UFCA FLORIDA GULF COAST HOSPITAL
Outpatient Rehabilitation & Diagnostic Center
DIAGNOSTICS MRI
ADDITION

HCA Diagnostic Center MRI Addition Bid Addendum No. 1

Date: 04/25/25

DAG Project #: 24107

FOUNDATION DETAILS

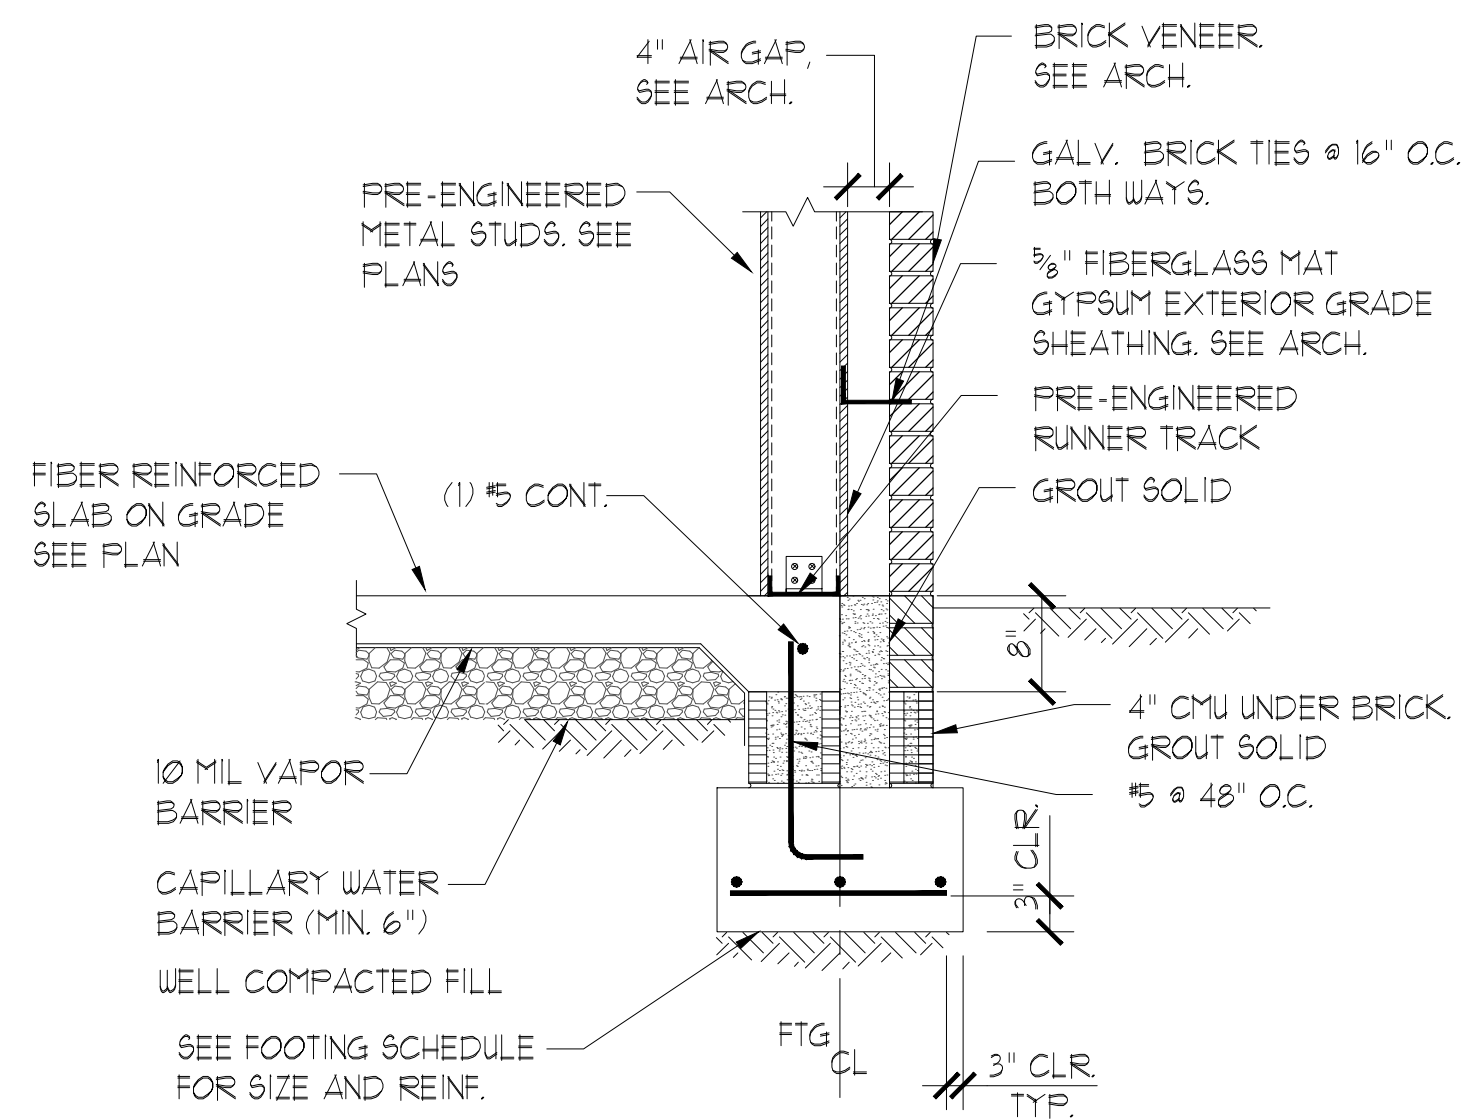
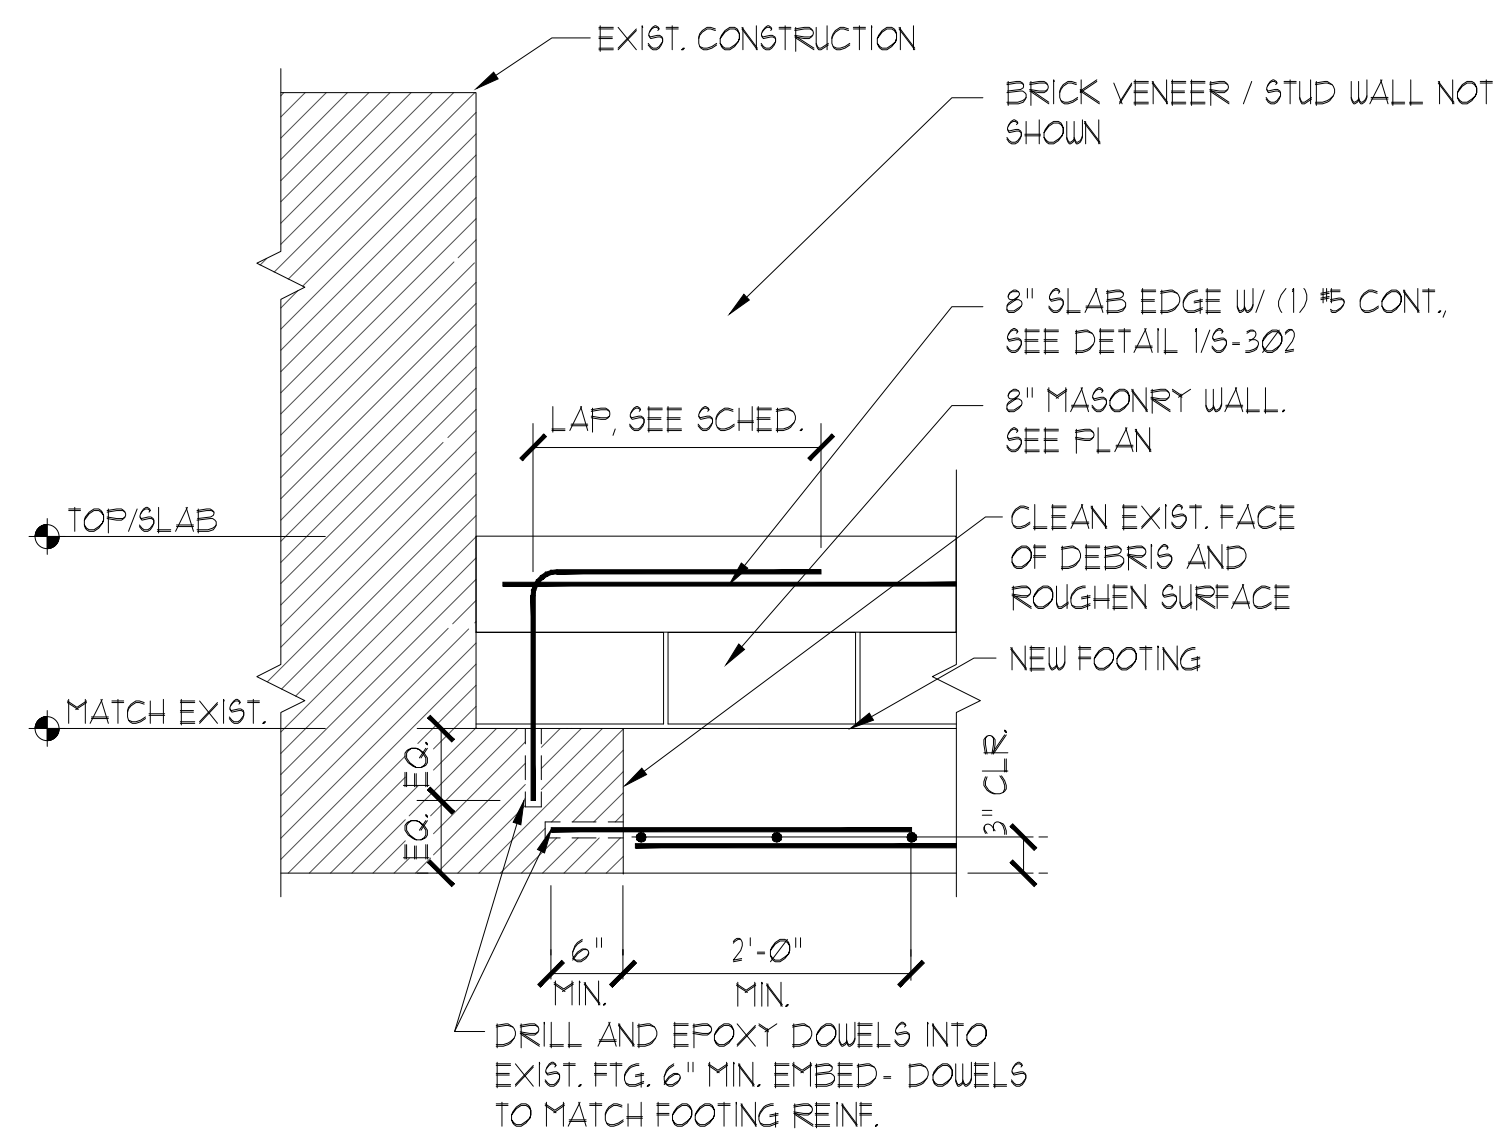
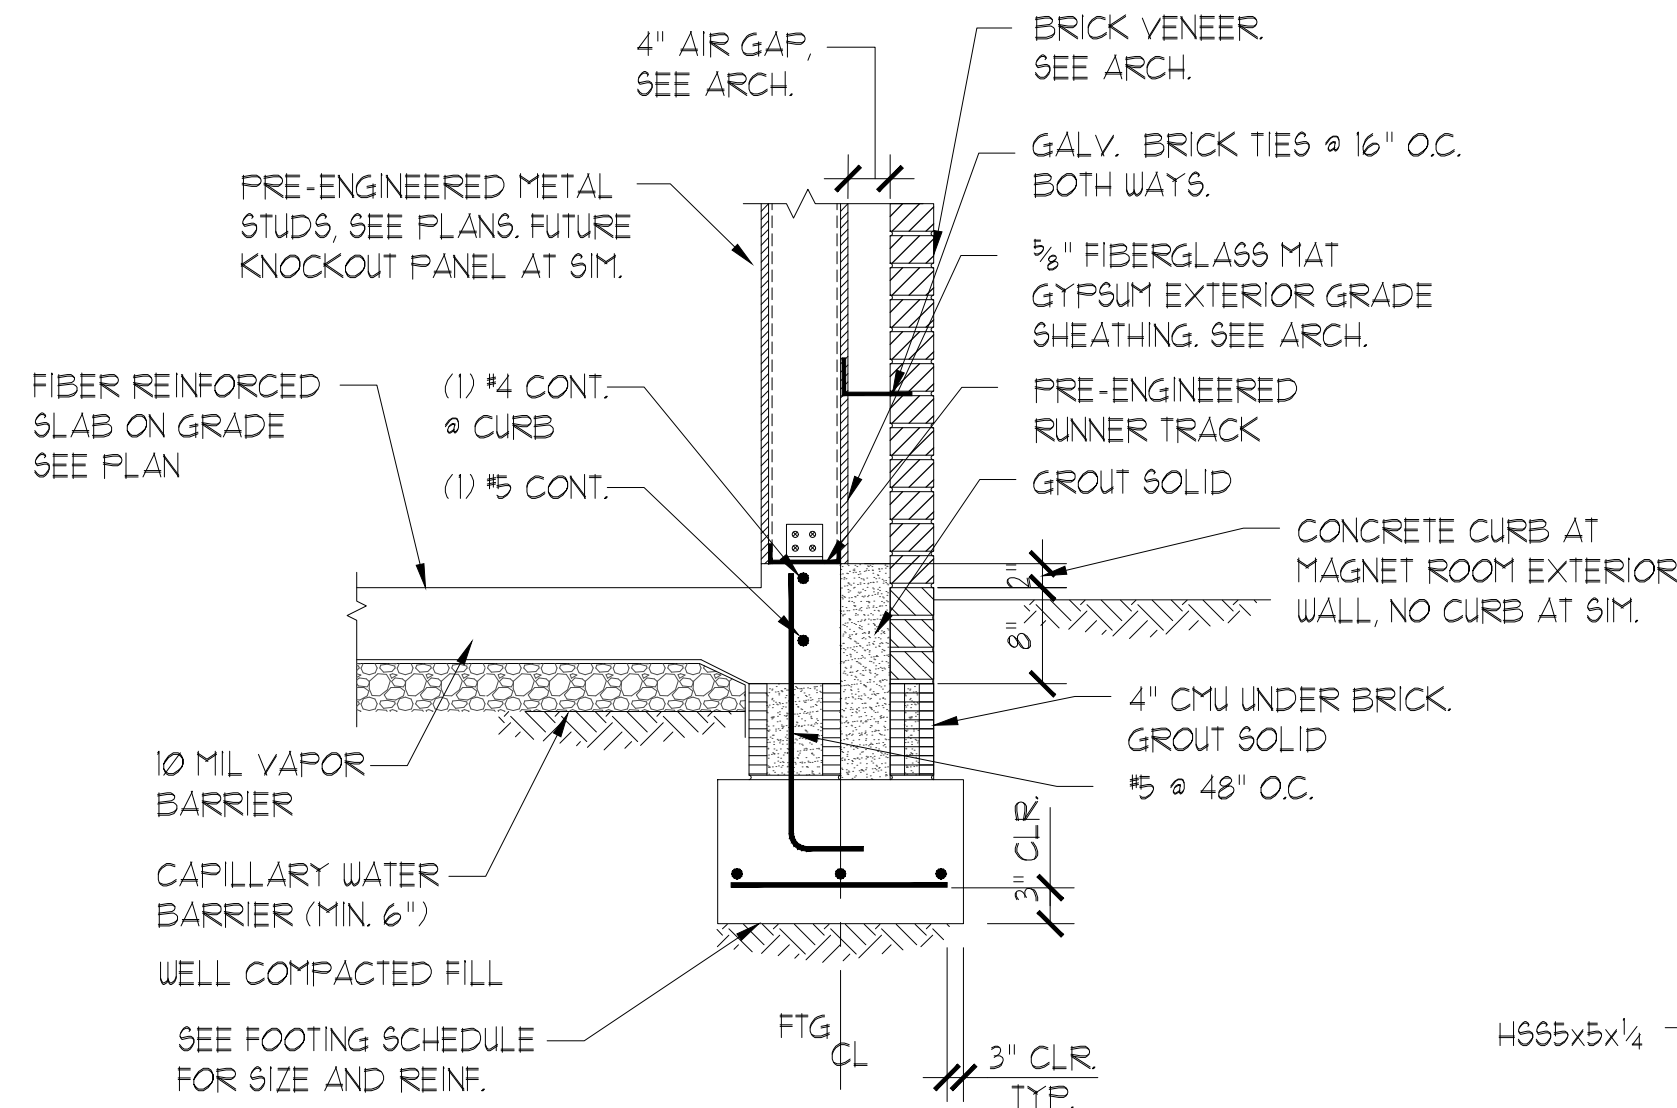
- 2.1 Q: A-101- It appears as if there is a curb or wall being referenced around the new chiller. If required, please provide detail.

Q: S-302- Architectural drawings reference a 1" expansion/isolation joint. Detail 2/S-302 reference a 1/2" expansion/isolation joint. Please confirm a 1" expansion/isolation joint is correct.

Q: S-302- Please confirm 4/S-302 is referenced to the correct location. If an 8" slab (or turndown) is required at this location, please confirm if an isolation joint is required.

Q: S-302- Perimeter turn down detail is referenced on 1/S-302 and turndown detail at MRI slab is reference at 5/S-302. Please provide detail showing where these two details meet.

A: A new curb detail for the chiller has been added to the Structural drawings.

A: The slab-on-grade does not require a 1" expansion joint, only a 1/2" isolation joint. The framing above the slab requires a 1" expansion joint as noted on the plans and details.

A: Detail 4/S-302 is cut in the correct location. It's cut looking at the outside slab edge transverse to the existing building showing how the new footing ties into the existing footing. There should be a 1/2" isolation joint where the 8" turndown abuts the existing slab similar to 2/S-302.

SITE PLAN

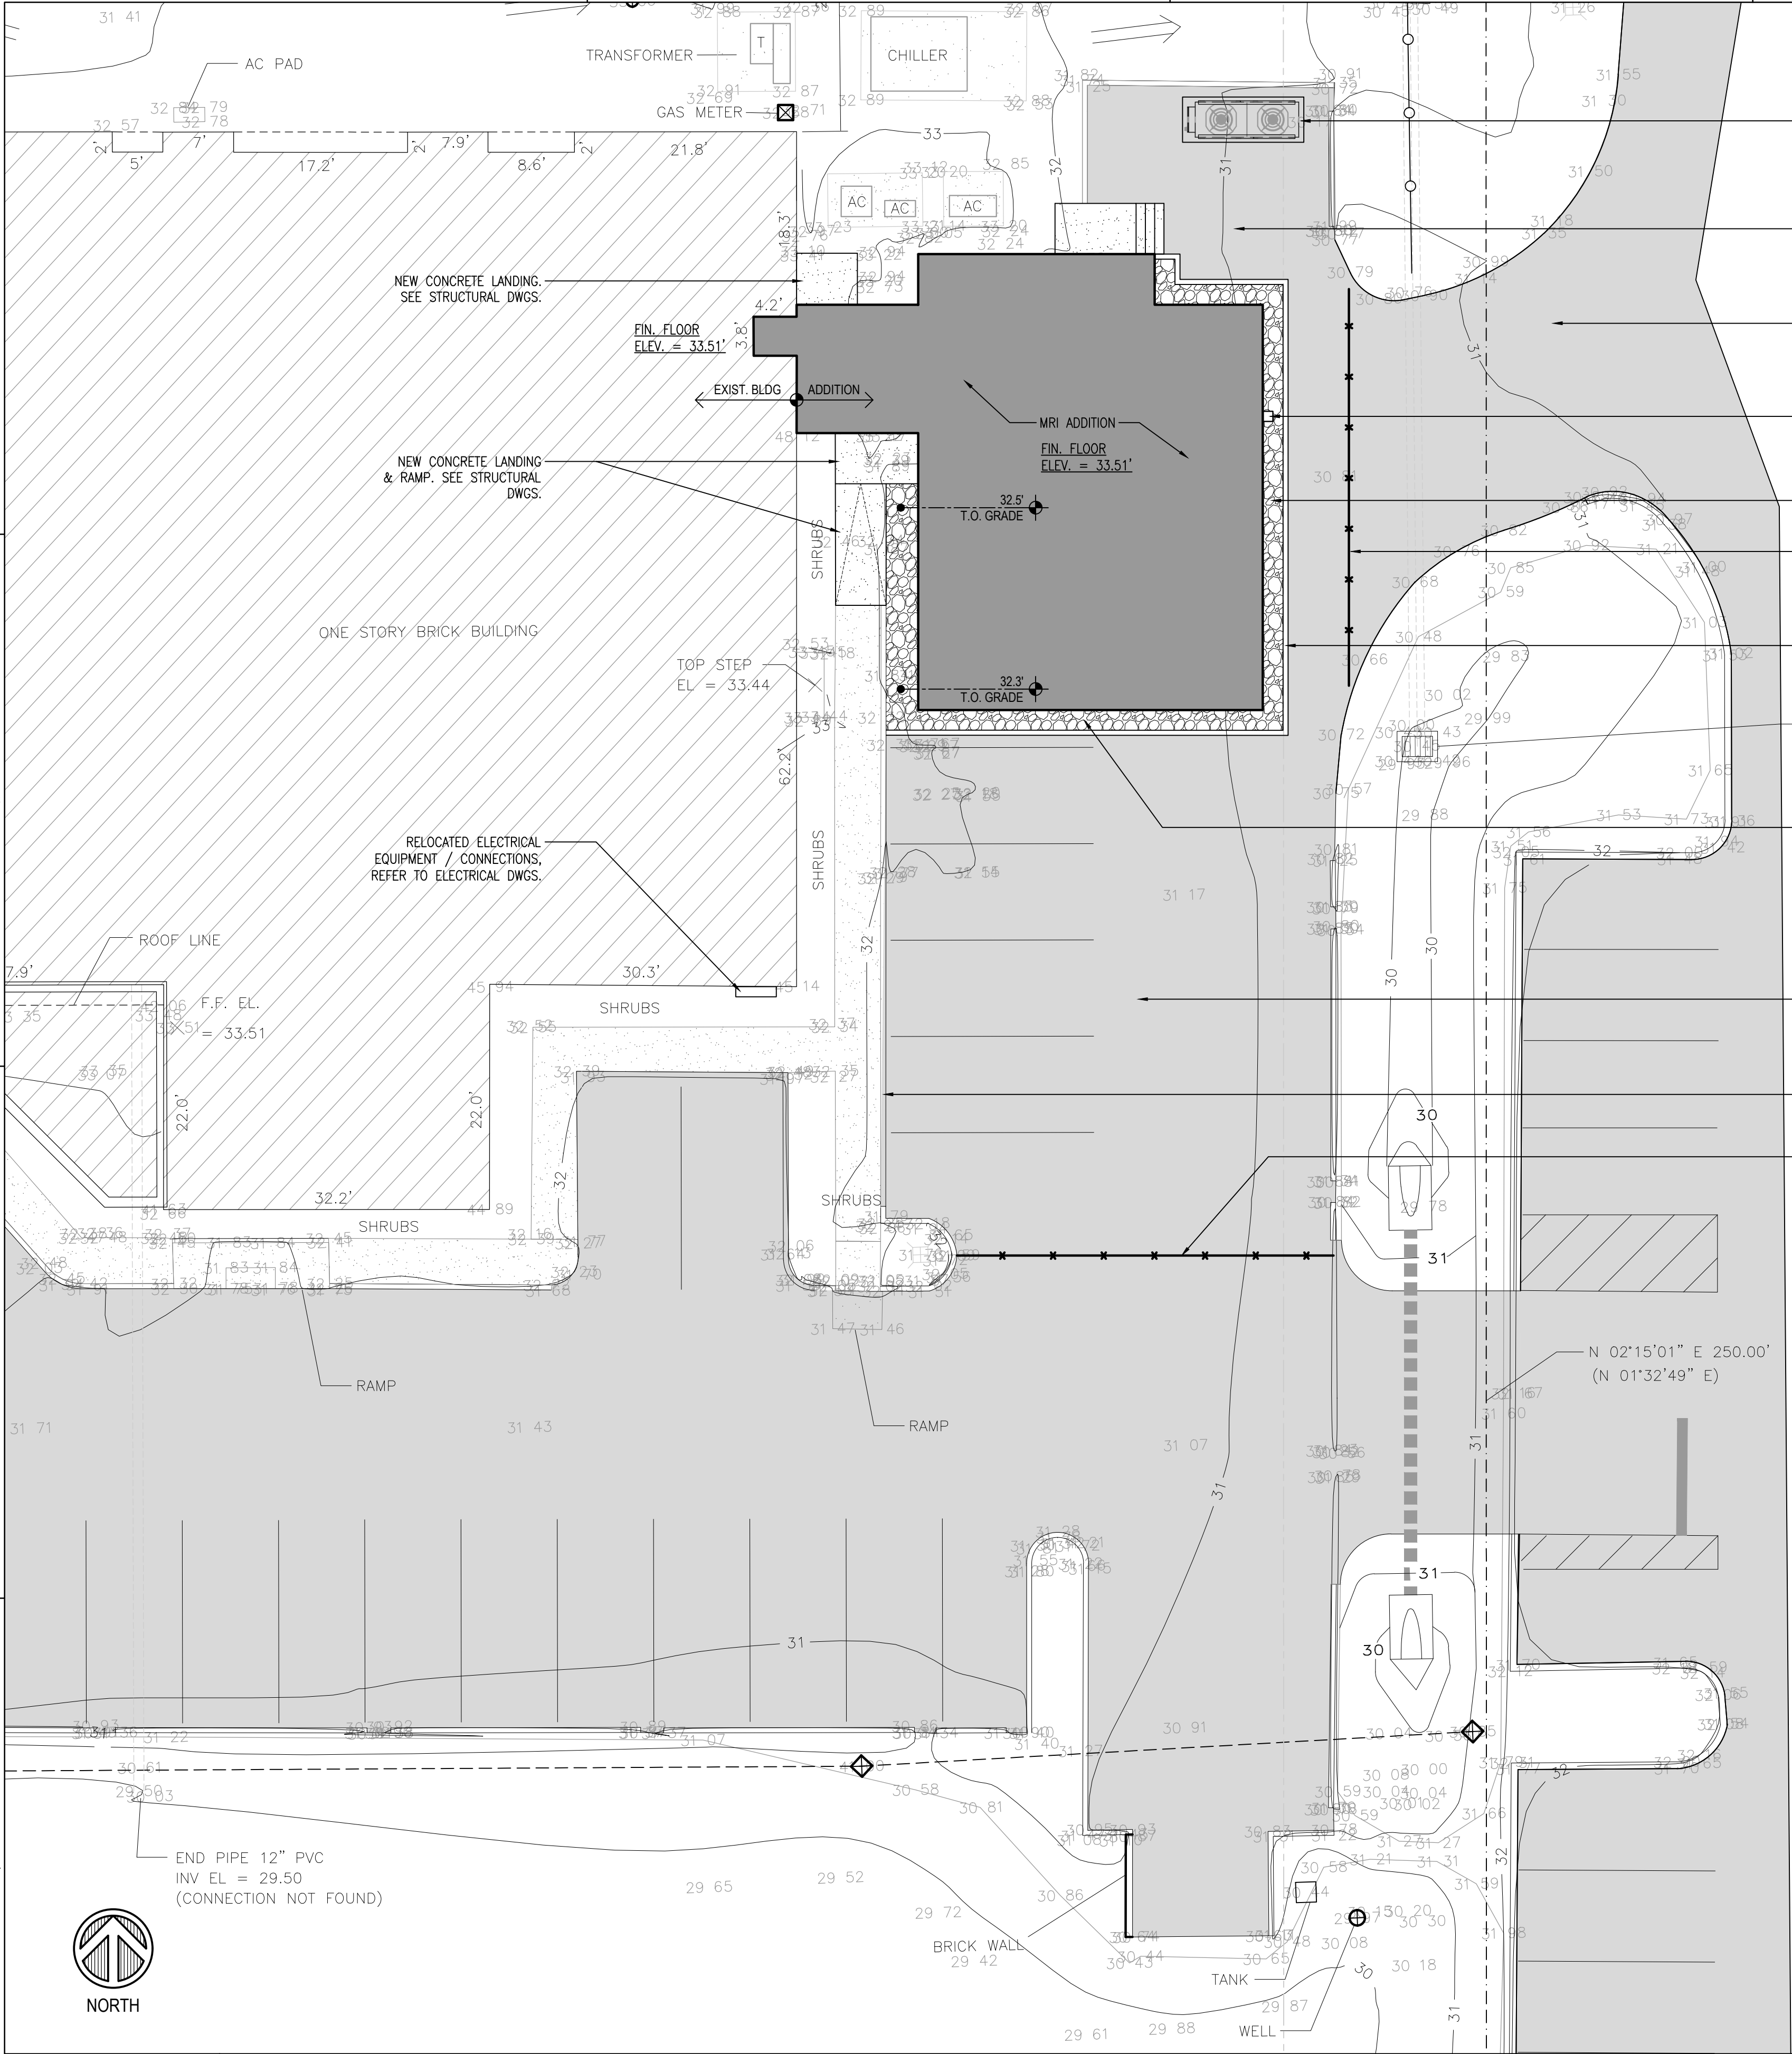
Q: General- Please provide any as-builts of underground utilities in this area.

Q: G-001- Provide Civil Drawings and limits of new pavement.

A: Existing conditions, underground utilities and topo lines have been added to the new Architectural Site Plan.

A: Civil drawings were not prepared for this project- refer to the new Architectural Site Plan. There is no new pavement work other than patch/repair damaged areas from construction.
